WEEKS MARINE INC.**WMI Job No. 2010-0148****REQUEST FOR INFORMATION (RFI) NO. 002****CONTRACT NO. B000964.001**

ARCADIS RFI number: 003,
Weeks RFI No 002

SECTIONS
SHEET 2 OF 3
STRUCTURAL

1 ELEVATION WALE MODIFICATIONS

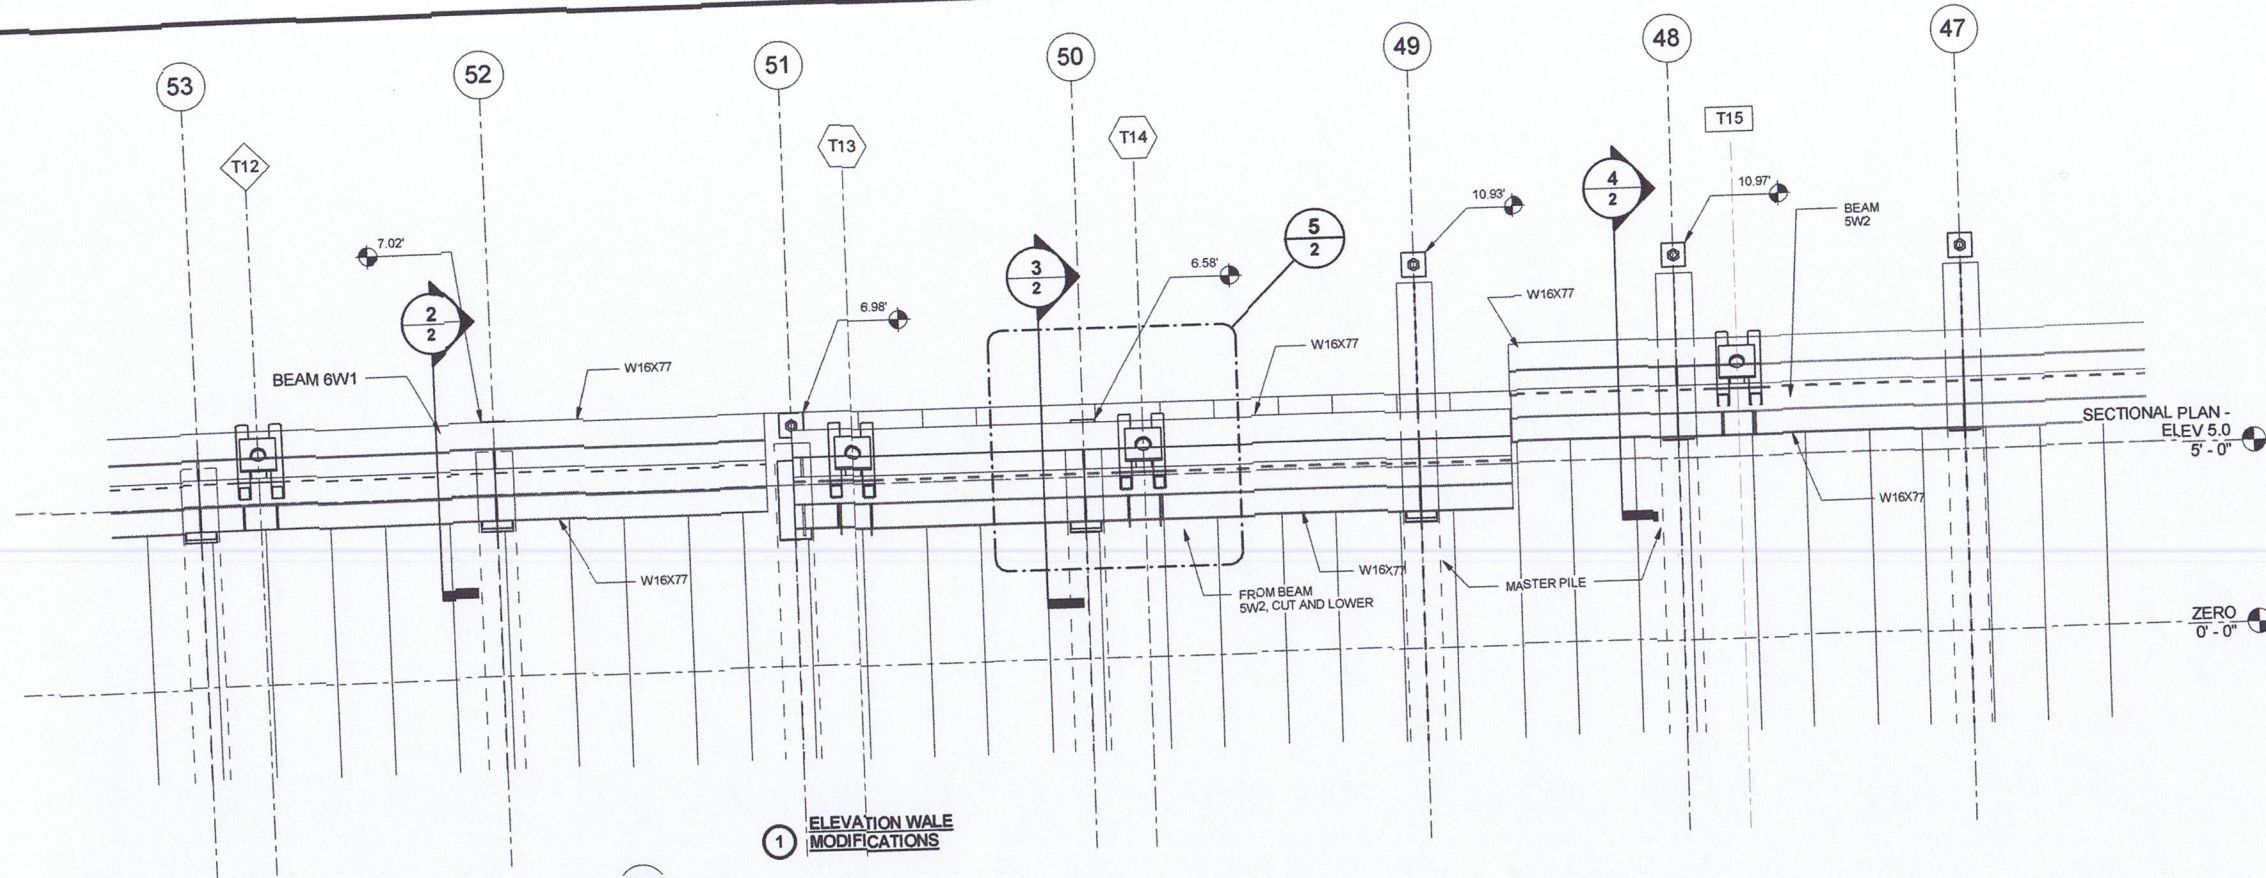
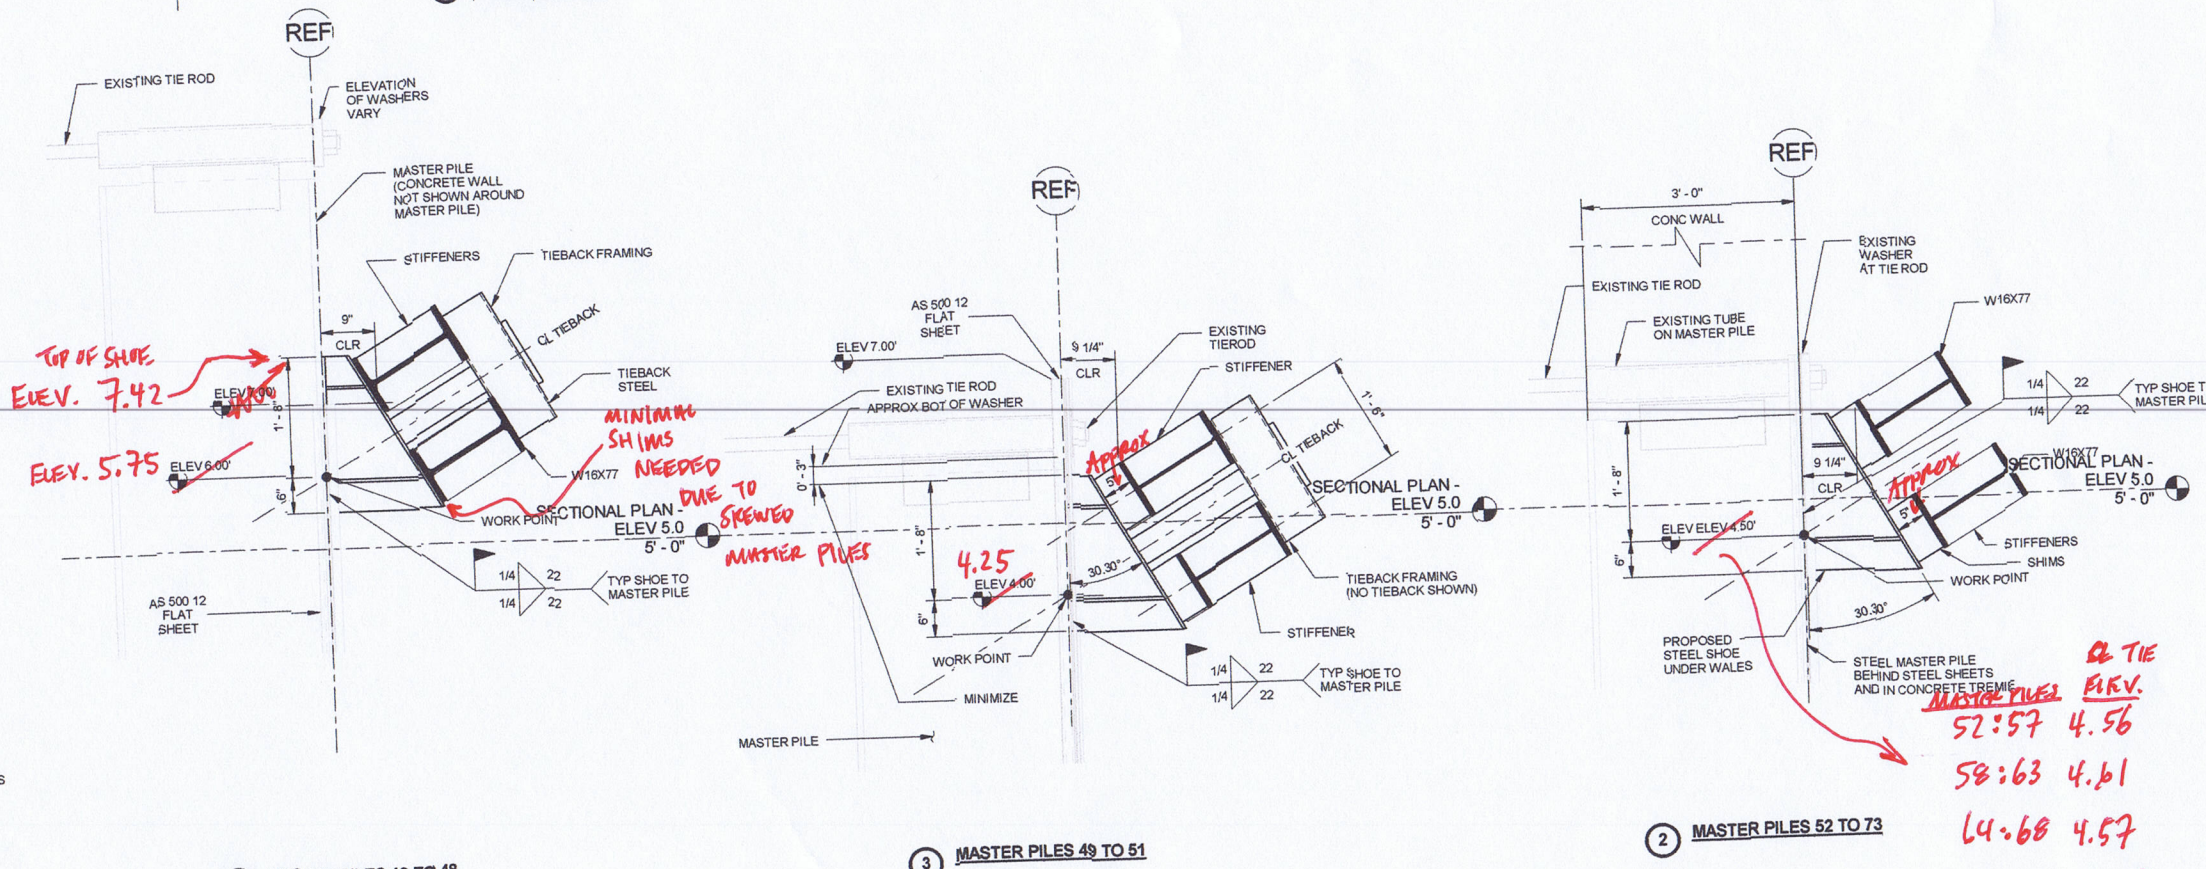
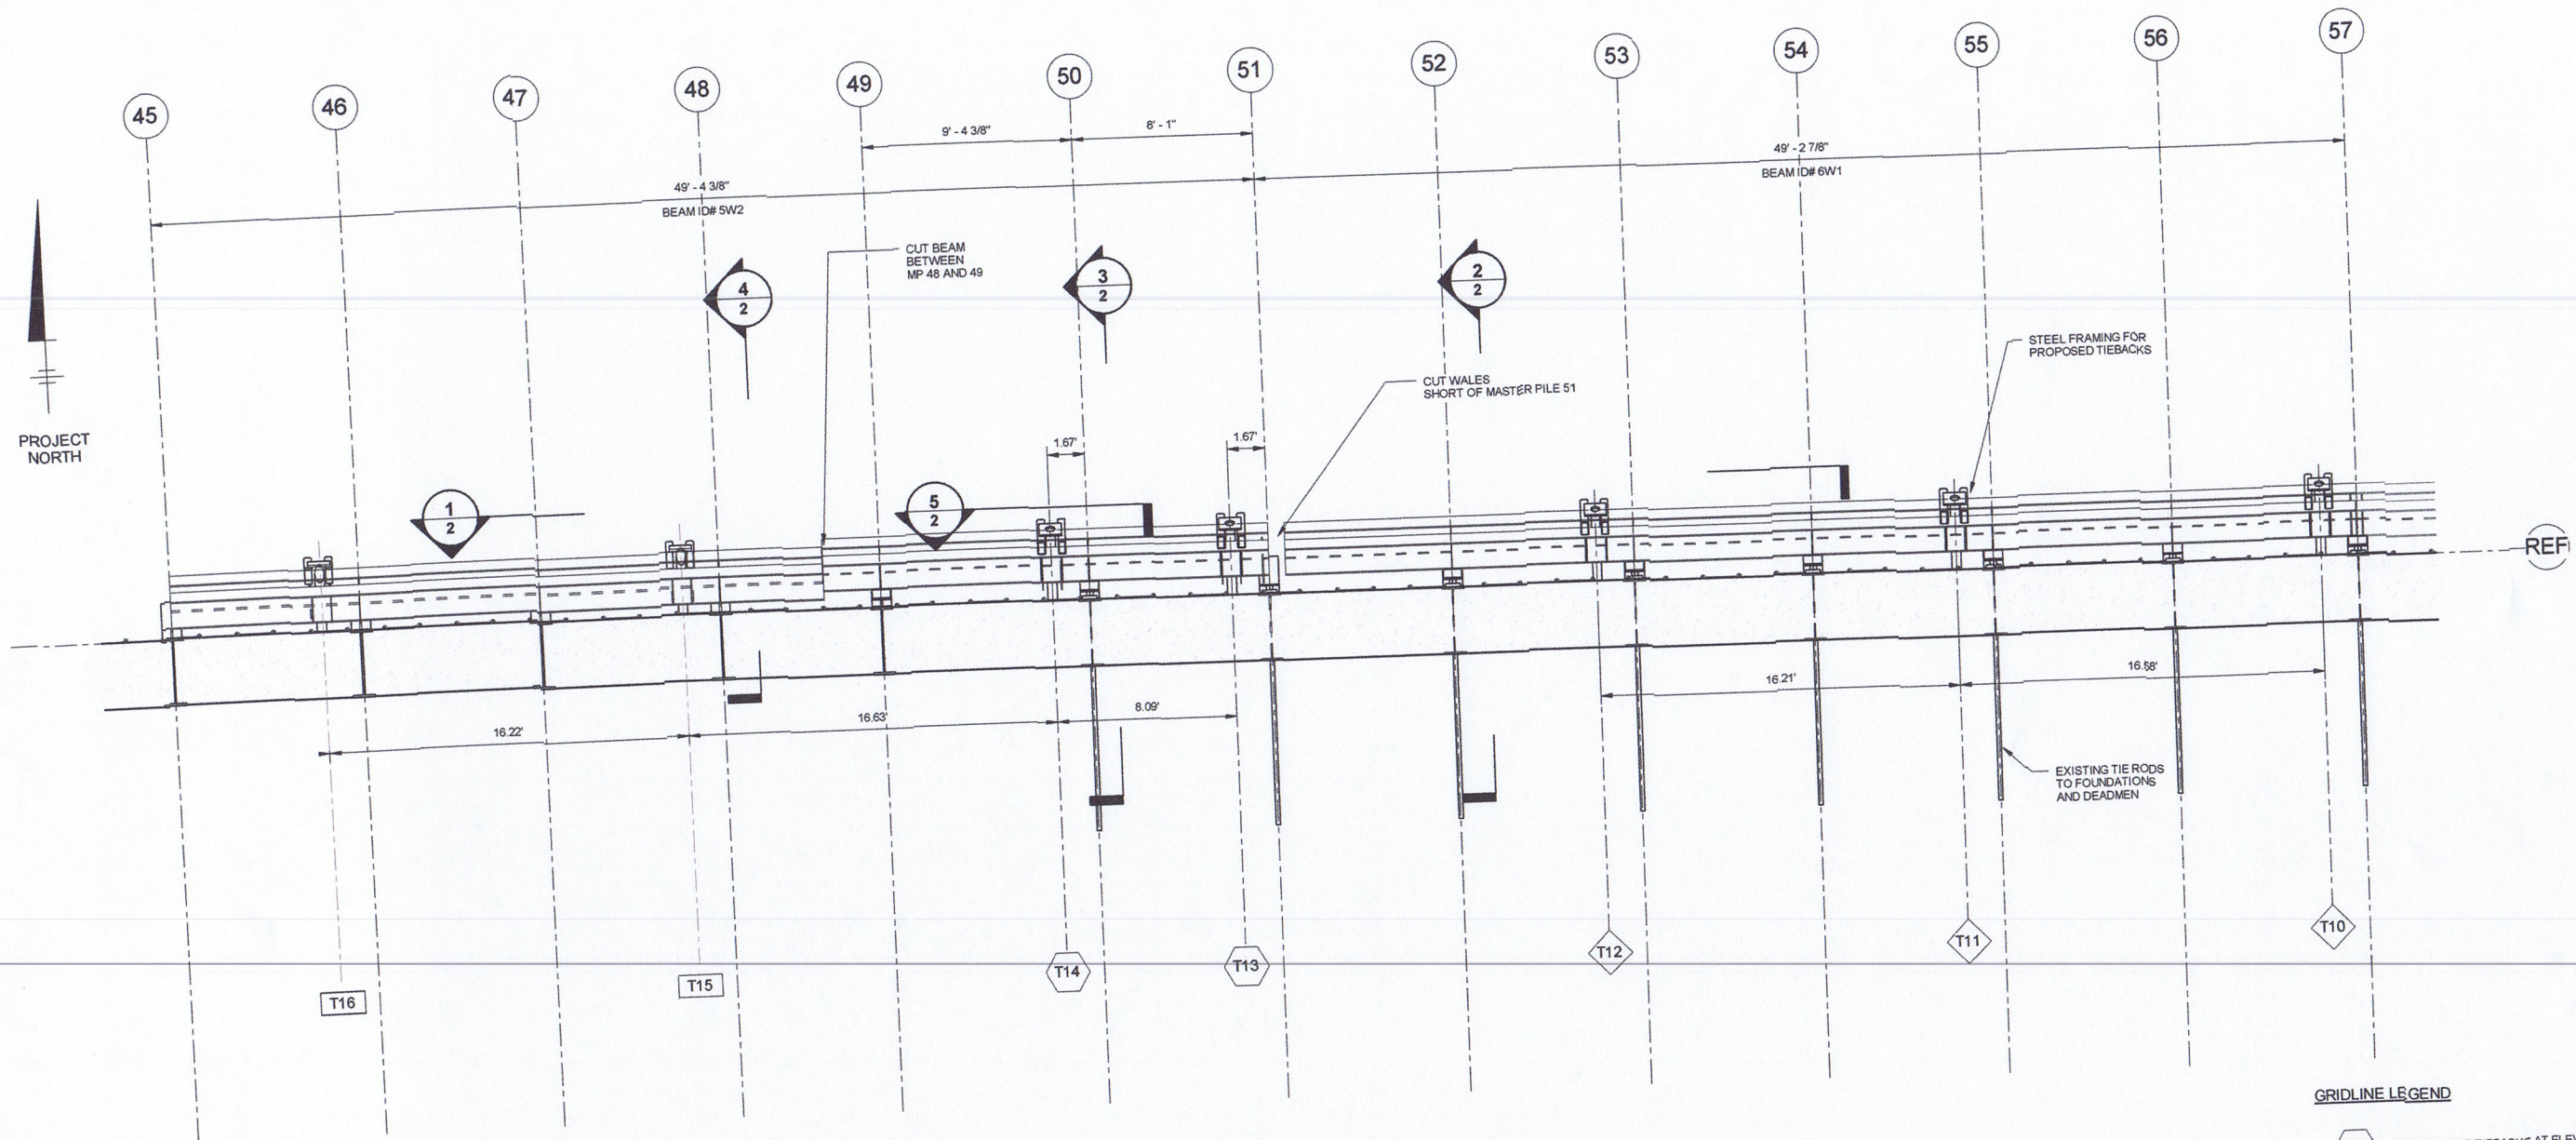
Coleman,
Attached is RFI 12 "New Tie-Back Elevations" along with amended Arcadis Tie-Back Design Drawings to reflect the elevation changes in the RFI. Coleman, once reviewed, please forward to Matt Bowman, Adam, and Aaron.
